Alabama State Port Authority
Addendum to R&P or Specification Booklet

Project Name Stacker Reclaimer 2 & 3 Procurement

Project No. 11367 **Task No.** 02 **Addendum No.** 1

Date: 6/20/2024

ALABAMA STATE PORT AUTHORITY
POST-DREDGE HYDROGRAPHIC SURVEY OF
GARROWS BEND BARGE LOADERS

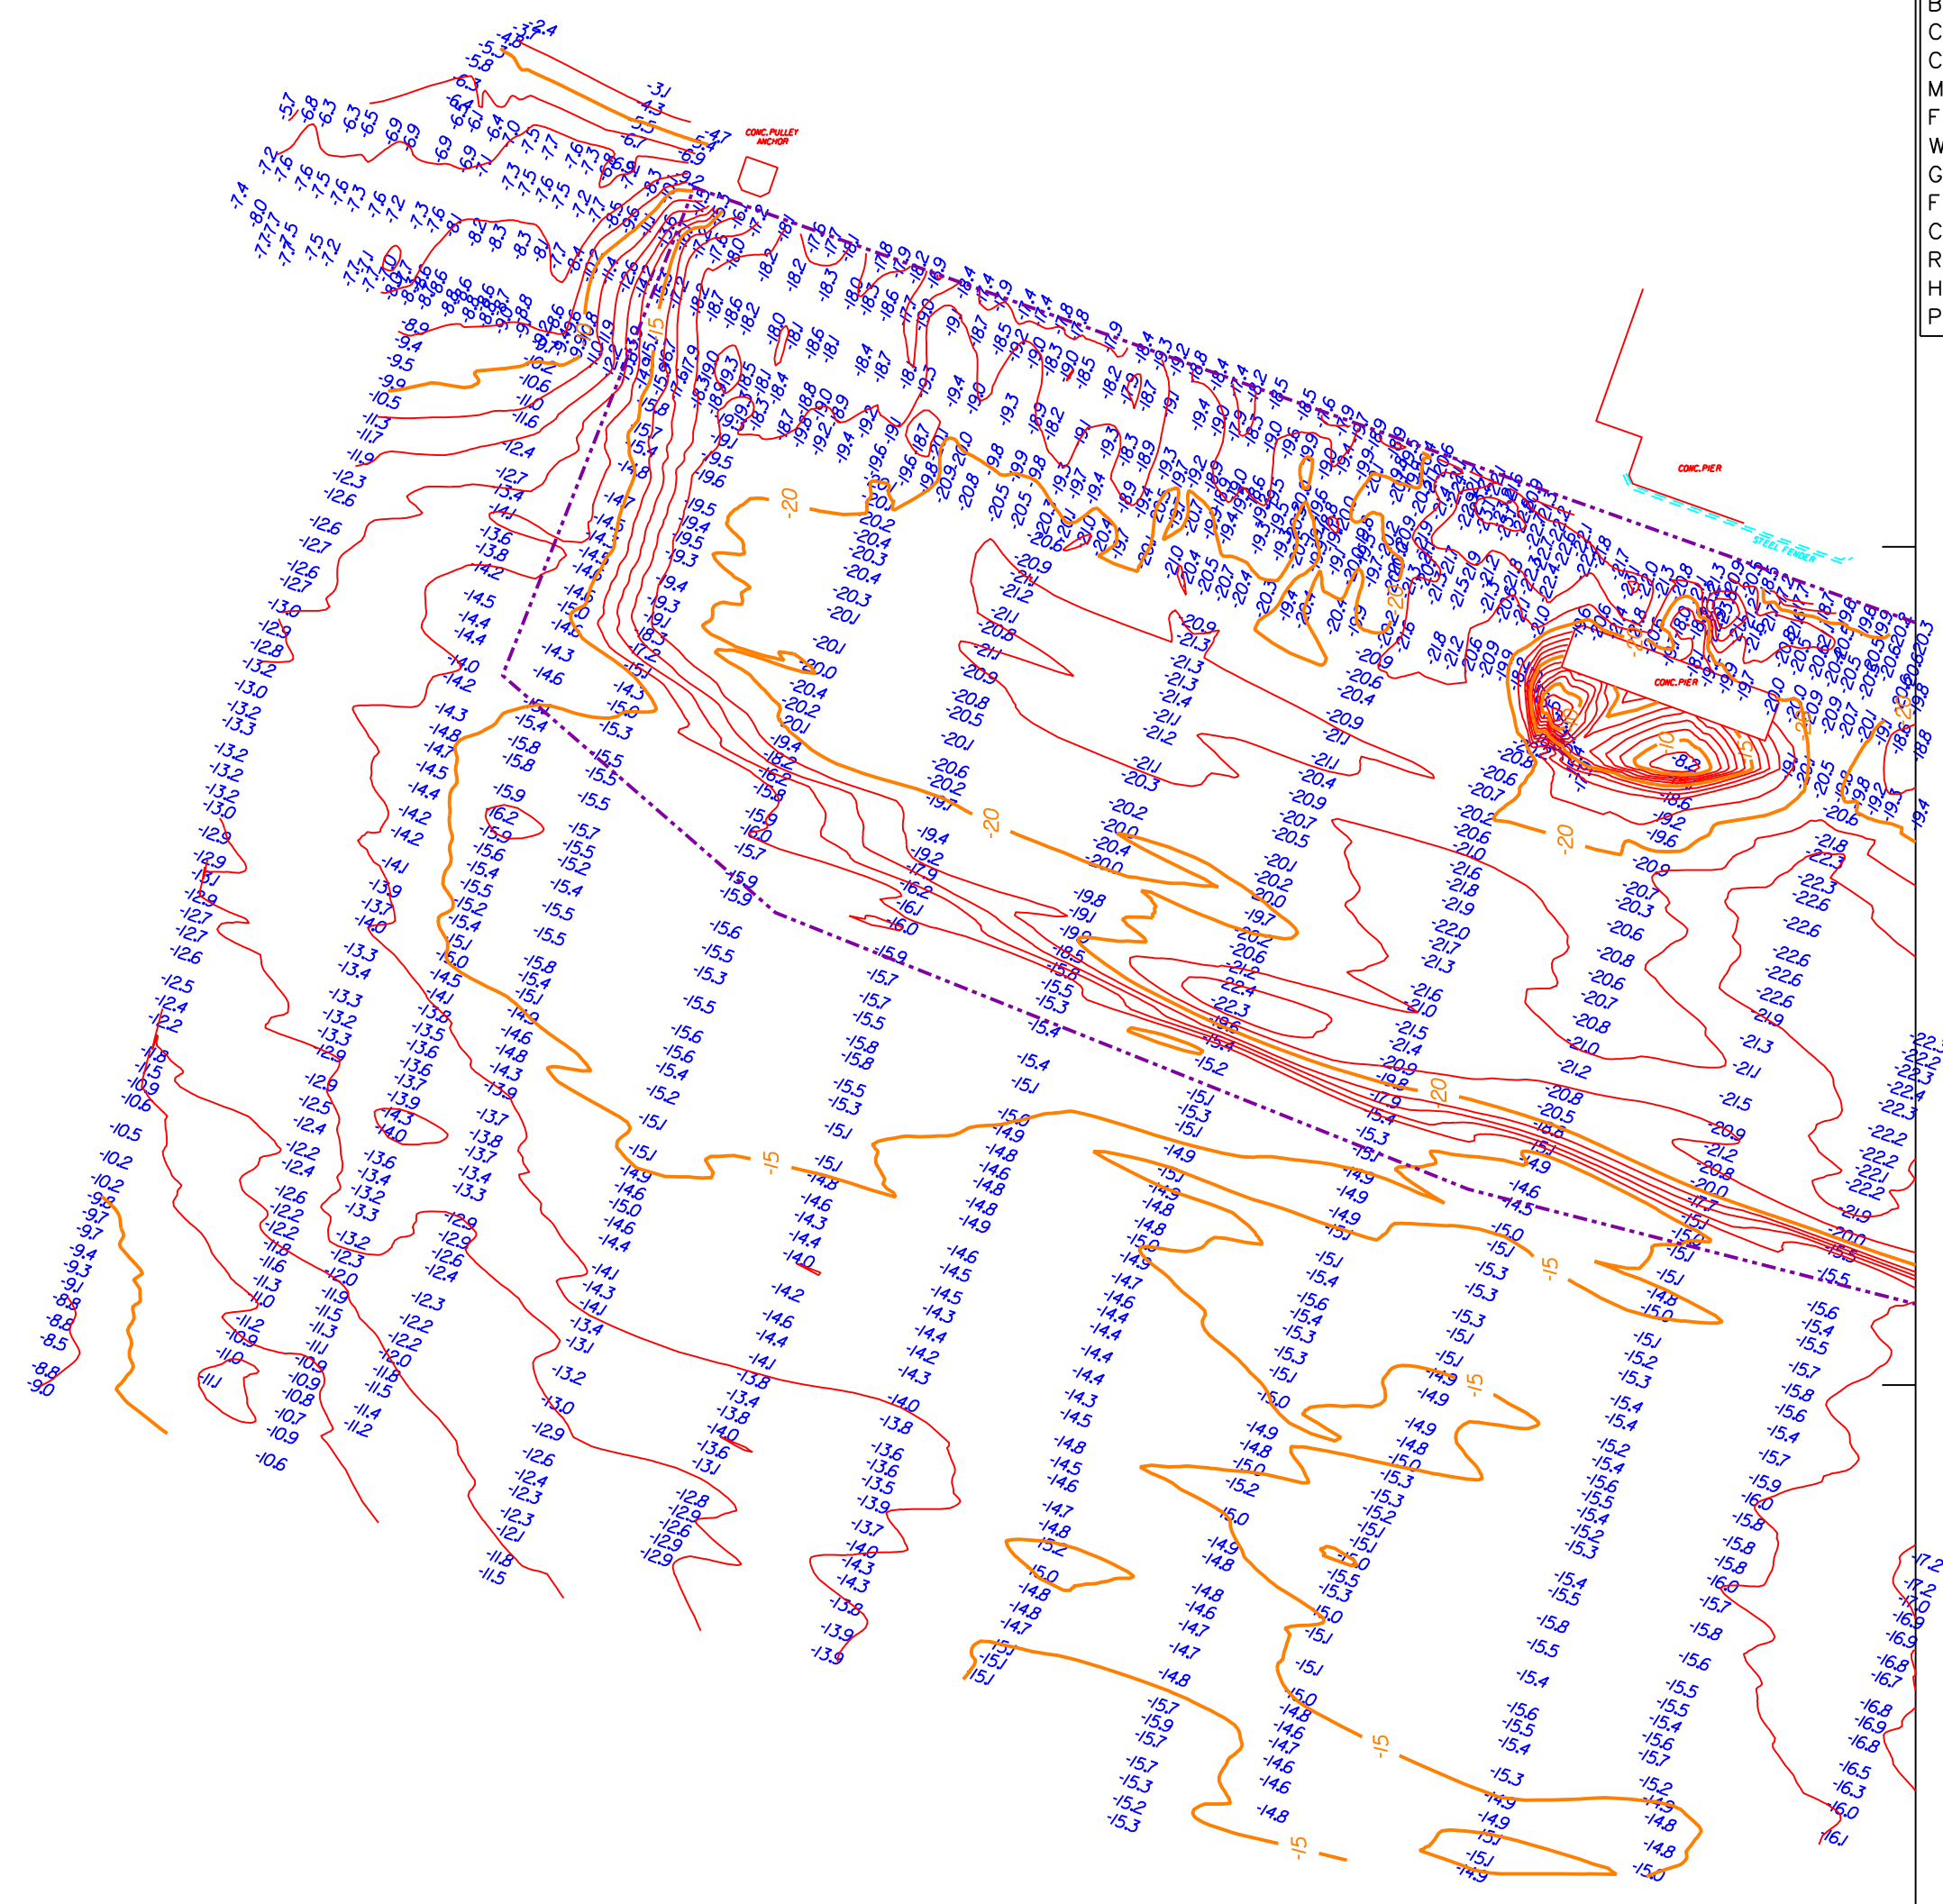
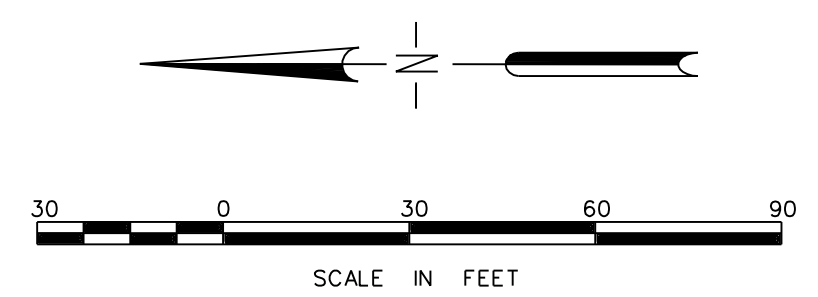
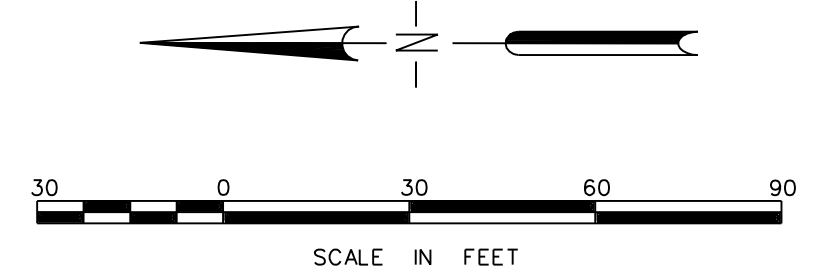
2.	<p>Question: Can the Port provide marine sounding reports for this area.</p>  <p>Answer: Please refer to the attached survey from June 2023 as attached – 23079-BARGE-LOADER-POST-DREDGE-6-6-23.pdf as the best available reference information.</p>
